Tennessee Valley Authority, 1101 Market Street, Chattanooga, Tennessee 37402

CNL-15-127

Watts Bar Nuclear Plant, Unit 2
Construction Permit No. CPPR-92
NRC Docket No. 50-391

Subject: **Revised FSAR Section 6.2.1 Containment Functional Design**

Figure 4.4.3-1 Containment Pressure Transient

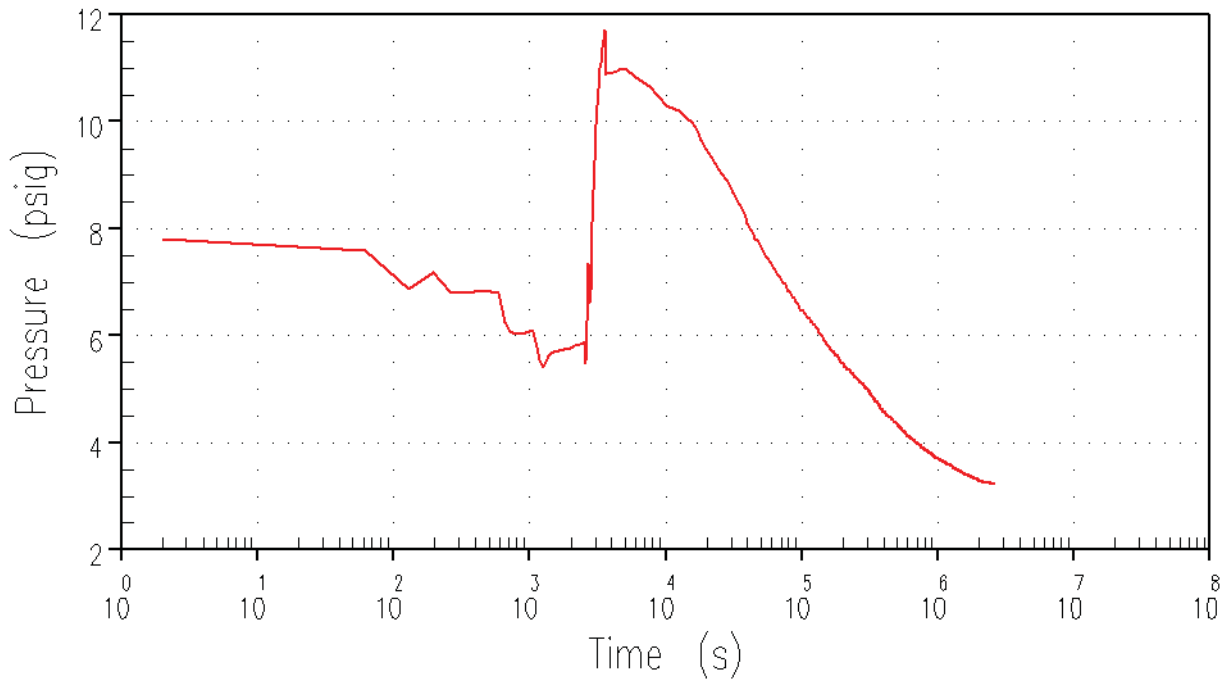
The results of the analysis show that the maximum calculated containment pressure is 11.73 psig, for the DEPSG minimum safeguards break case, assuming an ice bed mass of 2.585×10^6 lbm. This pressure is less than the design pressure of 15.0 psig as well as the administrative limit of 13.5 psig and, therefore, shows the acceptability for Unit 2. The pressure peak occurs at approximately 3,600 seconds (approximately 60 minutes), with ice bed melt-out at approximately 2,959 seconds (approximately 49+ minutes). It is noted that the apparent containment pressure margin between 11.73 psig and the design pressure cannot be used to further reduce the ice mass. The ice bed mass is limited by the spray switchover time of 2,718.7 seconds (approximately 45 minutes) and the margin between spray switchover and ice bed melt-out of at least 150 seconds (2.5 minutes).

Figure 6.2.1-1 Containment Pressure Versus Time

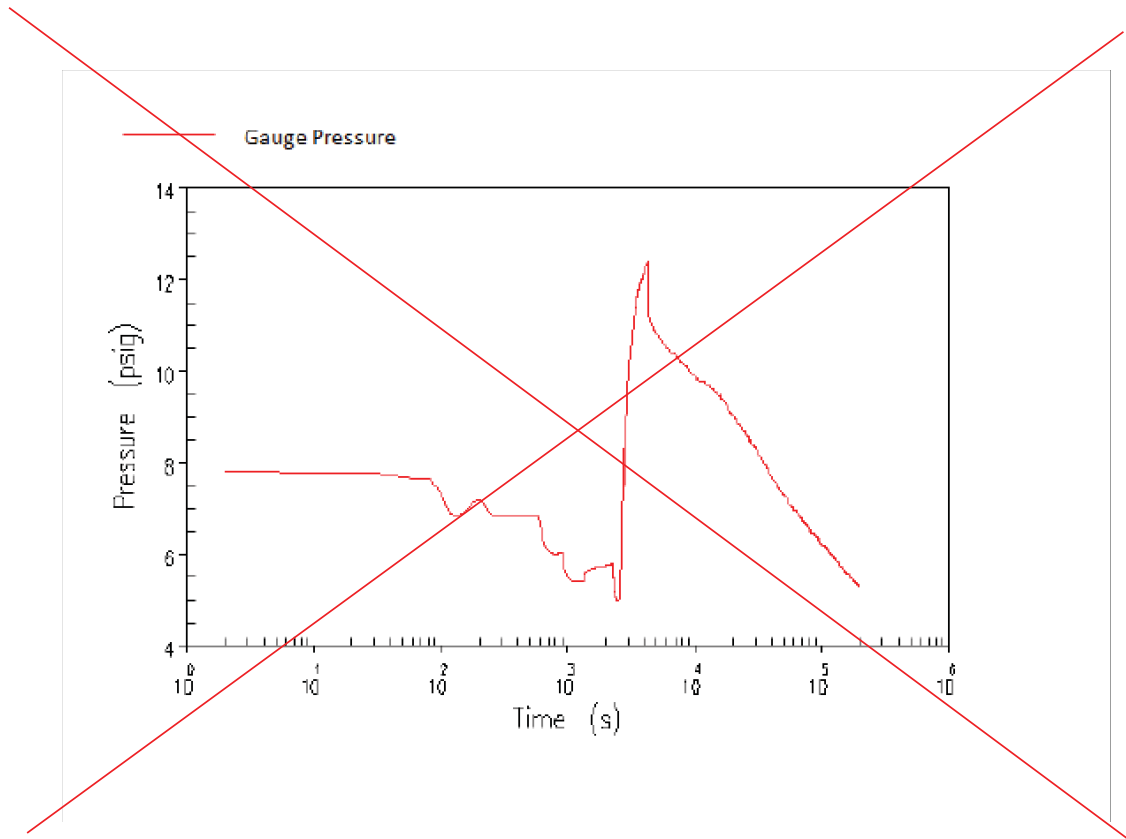
As can be seen from Figure 6.2.1-1 the maximum calculated Containment pressure is ~~12.40 psig~~, occurring at approximately ~~4346 seconds~~.
